1722a D7 Questions II

Aaron Gelter
January 13, 2014

- New SDI header proposal

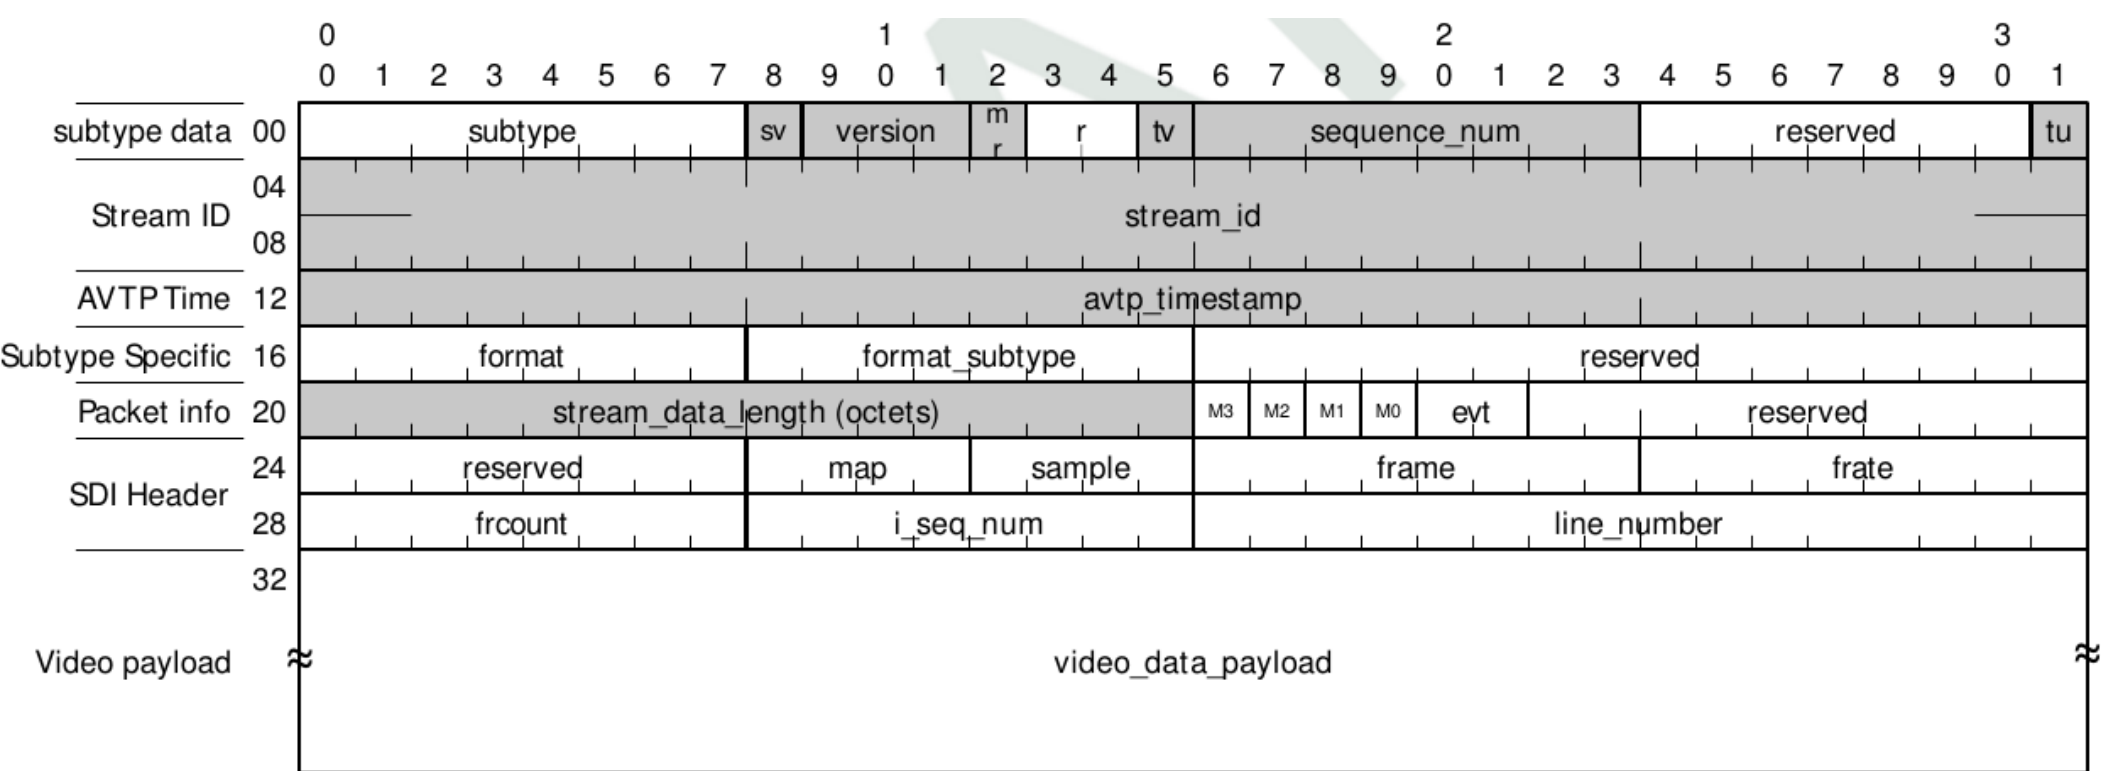
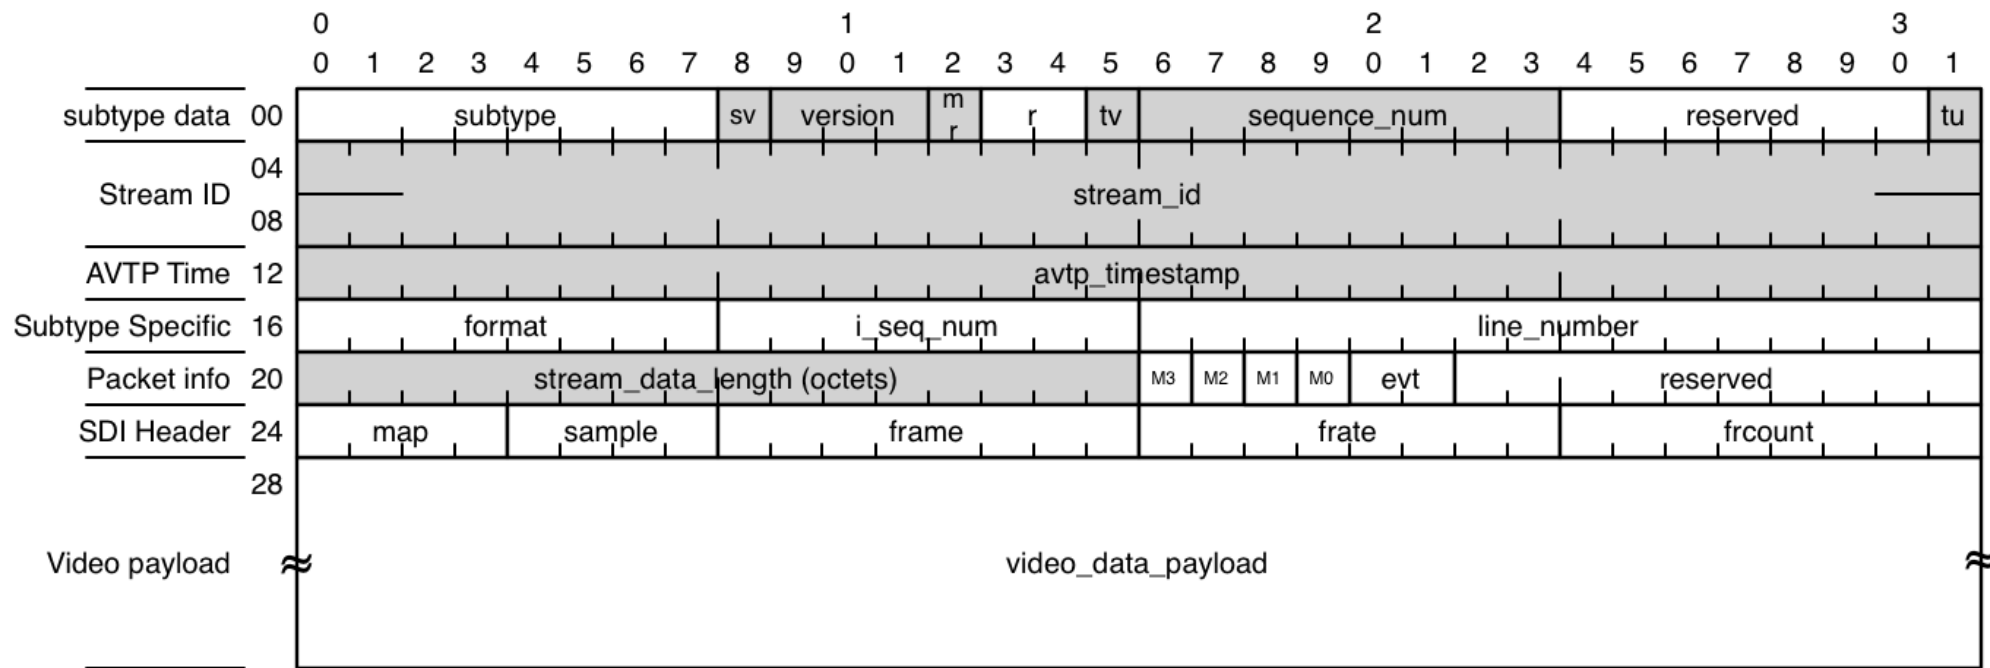
- D6 version of SDI (APVF) PDU
 - format field used to specify APVF vs RTP, etc.
 - format_subtype contains video source format information for APVF

- format field now contains SDI source format information
- format_subtype goes away
- Move i_seq_num and line_number into Subtype Specific header
- Consolidate 2022-6 fields into single SDI Header line
